Engineering Change Request		ECR Number		10415W
Initiator:	Wayne	Date:	2026.06.22	
Part number description				
Item	K3 Code material part numbers	Drawing/ Doc Number	Version of current related document	New Version
1	See attached list of changed part numbers	/	/	/
2	/	/	/	/
Reason of change:				
☐ Customer requirement (list the feasibility analysis of customer specification: _____) ☐ Supplier request (list the PCR number: _____) ☐ internal improvement ☐ corrective ☒ other				
Please describe here in detail:				
To improve the salt spray resistance of the locking screws on the back cover of the Gen3 CCS2 socket, the salt spray requirement has been upgraded from 96H to 240H. This change is solely for enhancing the product's salt spray resistance rating and has no impact on its original functionality..				
Change level and impact assessment (Please tick in the appropriate position)				
Change level	Change content	Concerned area (Shenzhen, Hermosillo, Chennai)	Whether to notify the customer

To improve the salt spray resistance of the locking screws on the back cover of the Gen3 CCS2 socket, the salt spray requirement has been upgraded from 96H to 240H. **This change is solely for enhanc

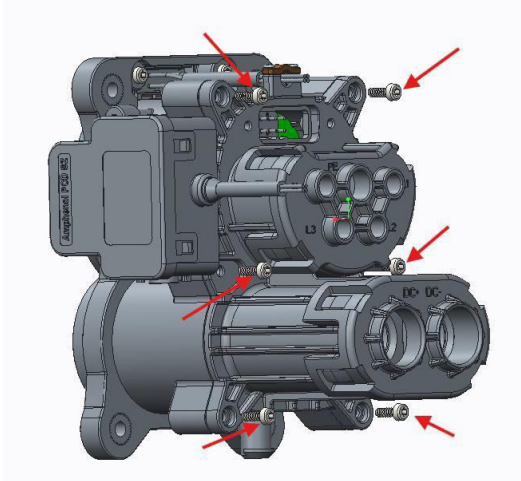
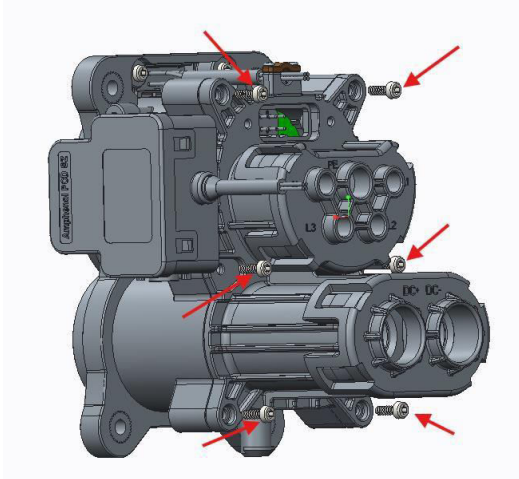
Before change		After change	
1. Salt spray requirement: 72H; Specification: ST2.9×10; Color: Silver 2. Part number: C210006302 		1. Salt spray requirement: 240H; Specification: ST2.9×12; Color: Grey 2. Part number: P01BM00214 	
Disposition of old materials ☐ Rework ☒ Use as it is ☐ scrap ☐ Other (please describe) : _____. ☐ N/A		Expect date to switch to new material <u>2026.07.15</u>	
Approval by the supervisor of requester.: <i>Jack</i>		Approval by the head manager of the request dept.: <i>dinghong</i>	
Customer approval : ☐ Approved ☐ No approved ☐ Conditional approval (please describe) : Signature : _____ Date : _____			
Remark:
